## SHEETZ JSP23-33

Public hearing at the request of Silken Gold for Preliminary Site Plan, Wetland Permit, Woodland Permit, and Stormwater Management Plan. The subject property is zoned B-3 General Business and is located in Section 13, west of Haggerty Road and south of Twelve Mile Road. The applicant is proposing to demolish the existing gas station on the site to redevelop with a new gas station/convenience store.

Re: JSP23-33 Sheetz Third Re-Submittal of Revised  
Preliminary Site Plan

# PLAN REVIEW CENTER REPORT

**Figure 1. City of Novi Regulated Woodlands Map**  
 Approximate Site boundary is shown in Red.  
 (Approximate) Regulated Woodland areas are shown in Green.

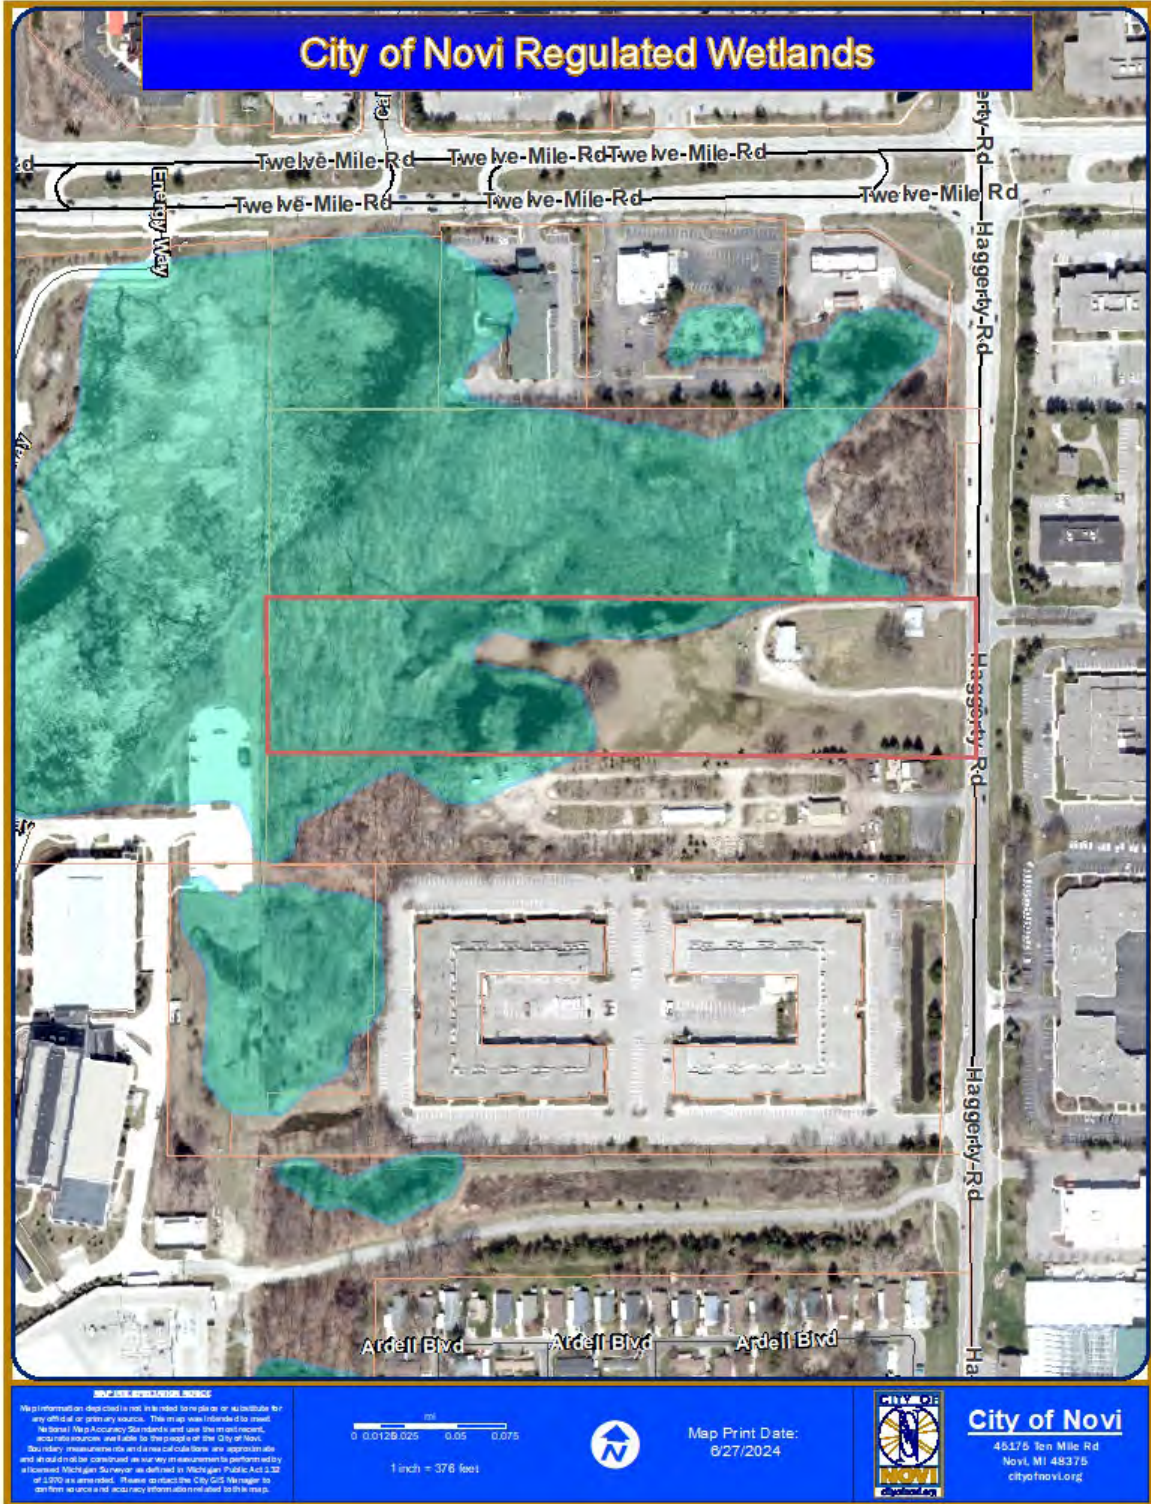
1. *Comment 1 from the PSP Review Letter is still applicable. City-regulated woodlands, as identified on the City of Novi Woodlands interactive map website, are likely present onsite. Note that both the woodlands and property limits depicted on the City map are considered approximations (Figure 1). A site visit was performed on March 26, 2024 to verify and review the extent of woodlands on-site. Figure 1 attached has a polygon showing the approximate woodland areas onsite.*

**Figure 2. City of Novi Regulated Wetlands Map**  
 Approximate Site boundary is shown in red.  
 (Approximate) Regulated Wetland areas are shown in turquoise

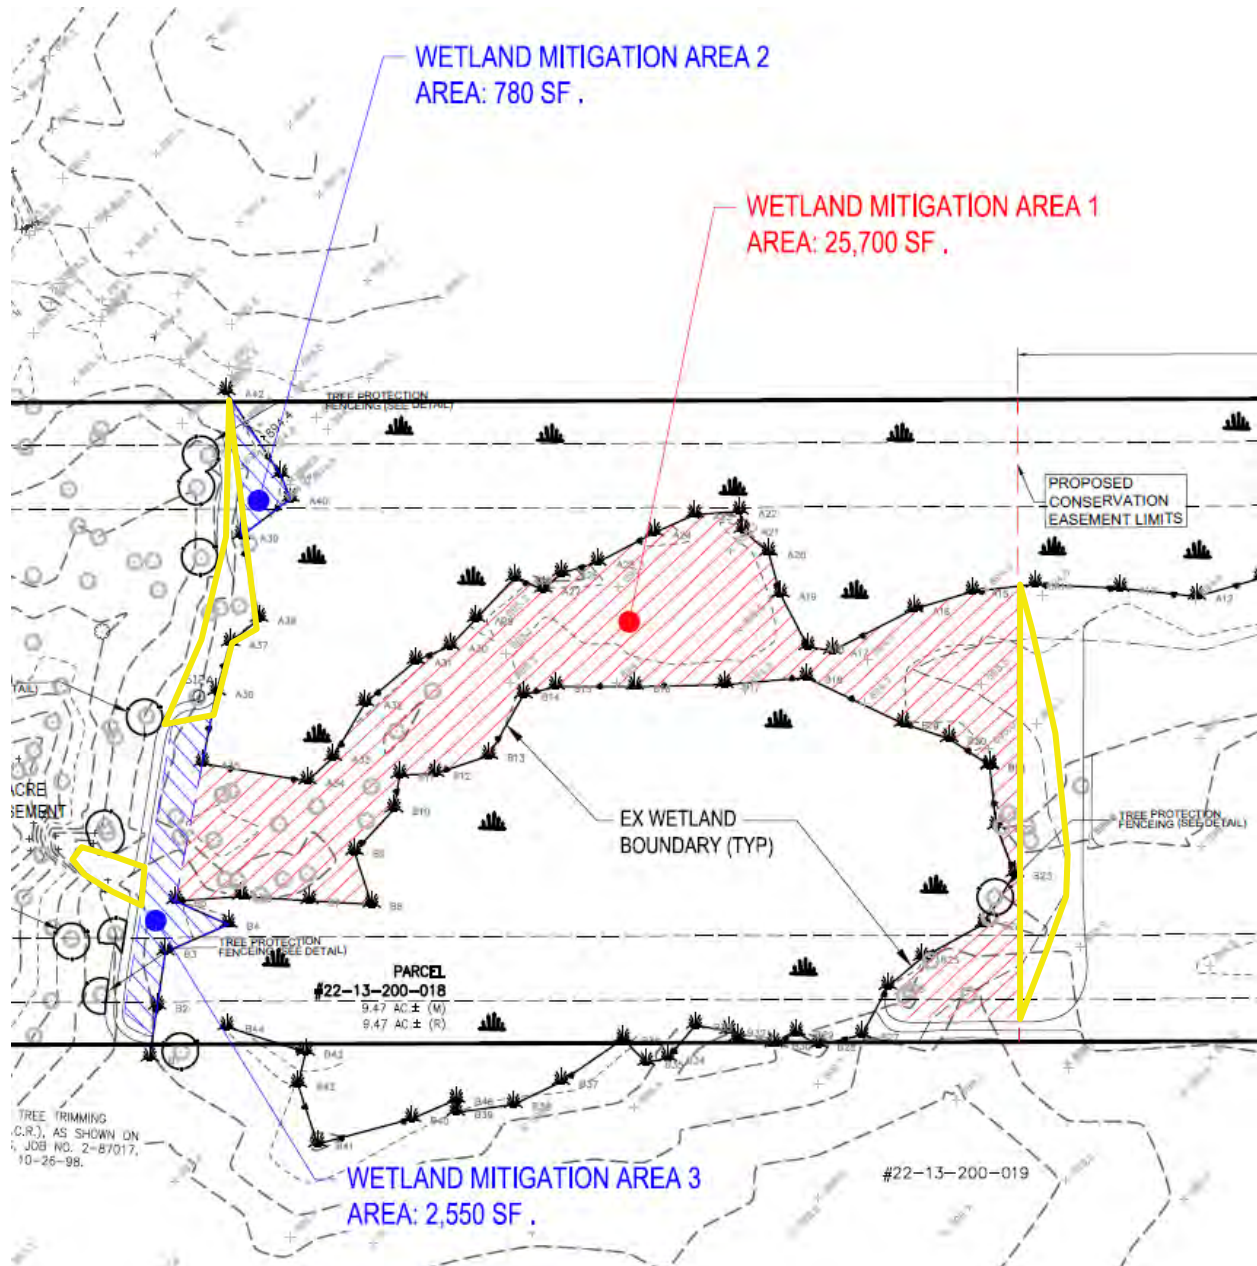
- City-regulated wetlands, as identified on the City of Novi interactive map website. Note that both wetland and property limits depicted on the City's map are considered approximations (Figure 2).
- Wetlands that are regulated by the Michigan Department of Environment, Great Lakes, and Energy (EGLE).
- Wetlands as identified on National Wetland Inventory (NWI) and Michigan Resource Inventory System (MIRIS) maps, as identified on the EGLE Wetlands Viewer interactive map website (PSP Review Letter). NWI and MIRIS wetlands are identified by the associated governmental bodies' interpretation of topographic data and aerial photographs.

H:\2024\20415.00\Sheetz Nowi, MI\Haggerty\Design\DWG\Sheetz Nowi\13 Wetland Plan.dwg

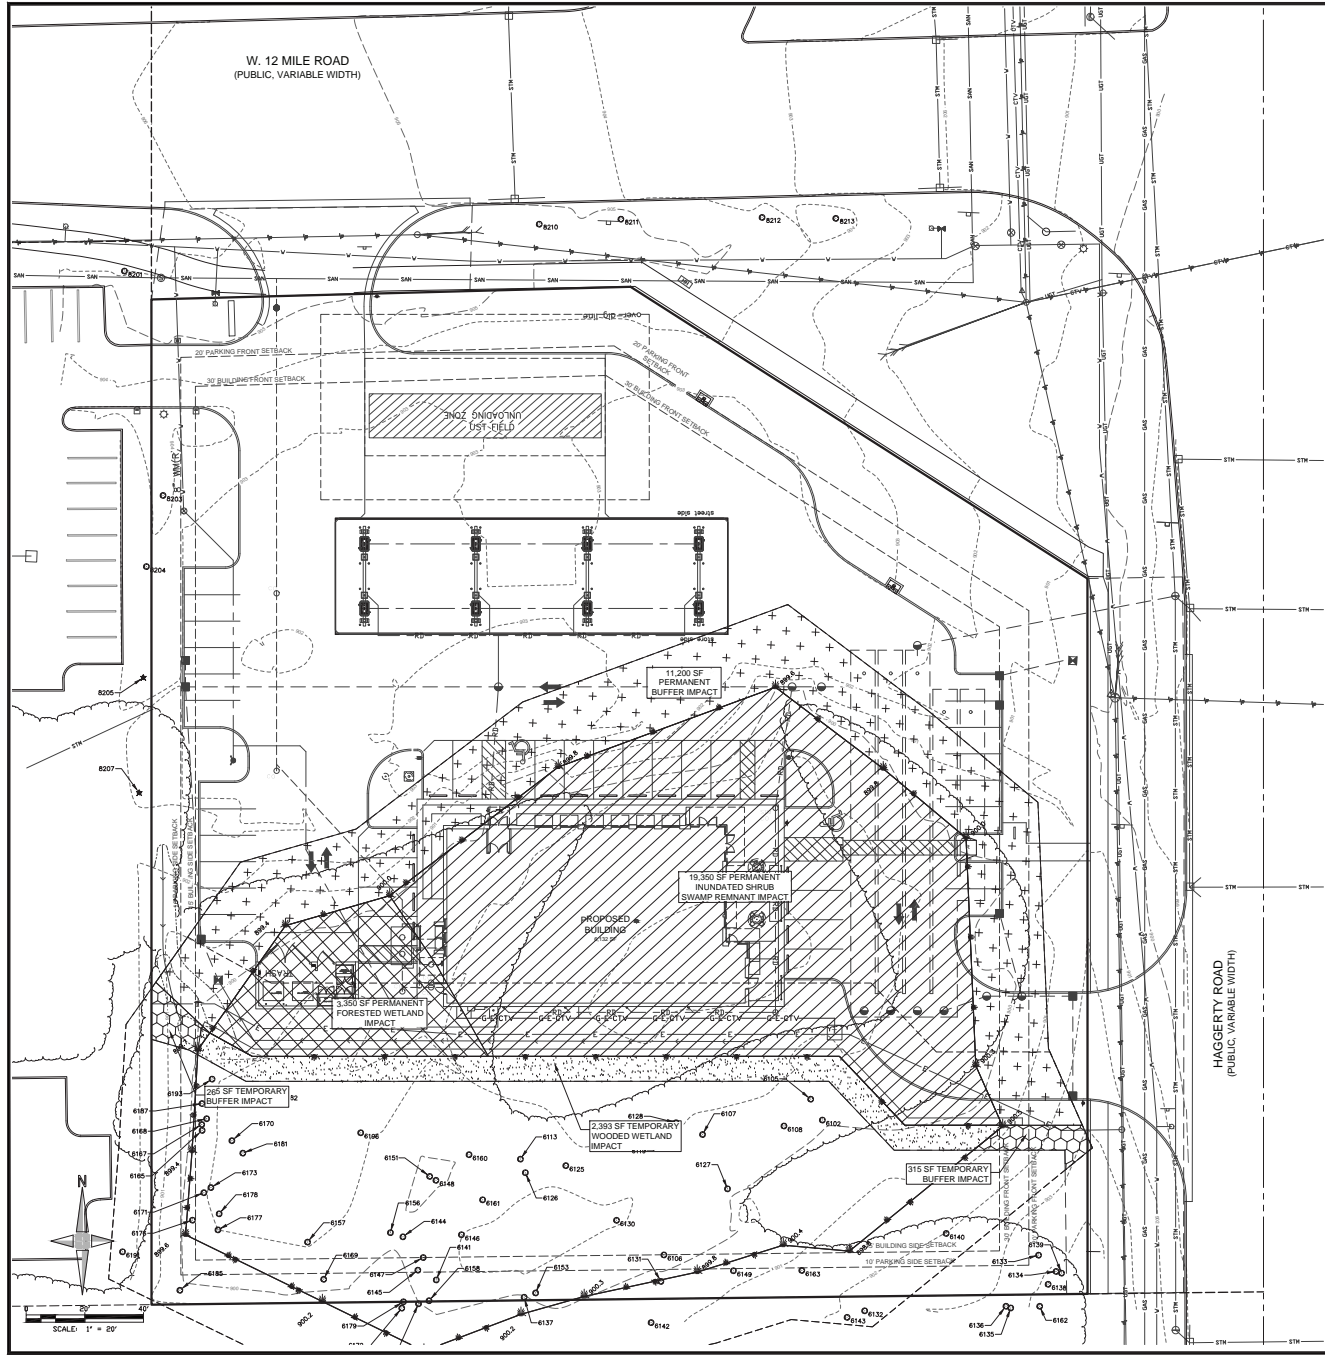
1. For final site plan approval, the applicant should list the type and reason for filling each wetland on Sheet 12 of the PSP. Information such as "X cubic yards of gravel overlain by X cubic yards of asphalt fill for parking lot/road," would be beneficial when preparing the Wetland Use Permit if this project is approved.

2. Sheet 12 of the PSP states that off-site mitigation is proposed. Additionally, Sheet 05 states that "XXXXXX" lists mitigation information (not provided in PSP). Due to the need for approximately 1.00 acre of wetland mitigation, the applicant shall provide a conceptual mitigation plan either appended to the PSP or within the PSP. The conceptual mitigation plan should contain the following information:
